Work Order ID 135668

Item Name: Replacement Skidtube (Fits LH or RH)

DRAWING NO. D2650	TITLE 206/407 SKIDTUBE ASSEMBLIES	REV. F	DART AEROSPACE LTD ENGINEERING ORDER		D.E.O. NO. D2650-F-1	SHEET NO. SHEET 1 OF 1	SCALE NTS
DRAWN <i>AP</i>	CHECKED <i>AP</i>	MFG. APPR. <i>AA</i>	APPROVED <i>AA</i>		DE APPR. <i>AA</i>		
DATE 12.10.12	DATE 12.10.22	DATE 12.10.22	DATE 12.10.22		DATE 12.10.22

DETAIL G

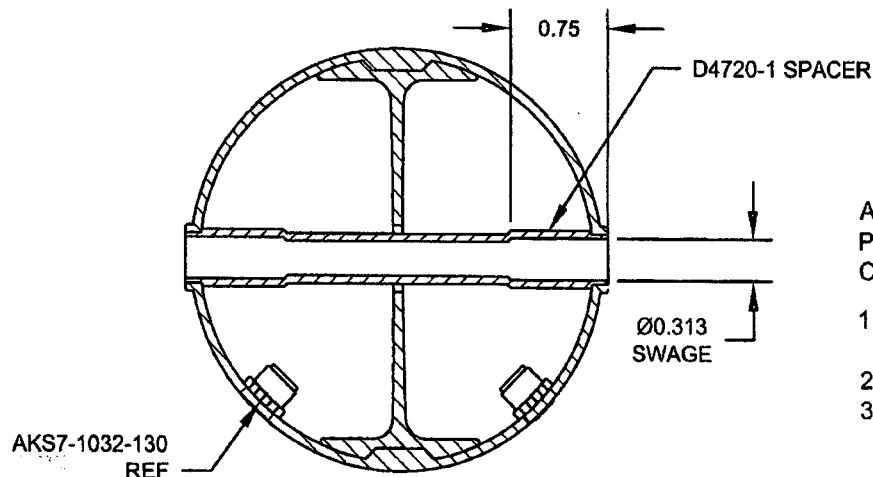
CHANGE C'BORED WELDED CROSSBOLT SPACERS TO SWAGED SPACERS

ADD DETAIL G BELOW, WHICH IS THE SAME SECTION VIEW AS DETAIL D OF DWG.
C'BORED HOLES ARE **NOW SWAGED** PER DETAIL G BELOW. FOR THE Ø0.375 HOLE THAT IS NOT C'BORED, WELD PER DETAIL D OF DWG (SEE AMENDED DETAIL B FOR REFERENCE).

AFTER DRILLING AND BENDING ASSEMBLY
PERFORM THE FOLLOWING FOR Ø0.375 HOLES THAT ARE
CURRENTLY C'BORED:

1. INSERT D4720-1 SPACER, 16 PL (-1) OR 17 PL (-3)
OR 19 PL (-5) OR 23 PL (-7)
2. SWAGE TO Ø0.313 X 0.75 DP PER QSI 002
3. TRIM / GRIND FLUSH PER QSI 002
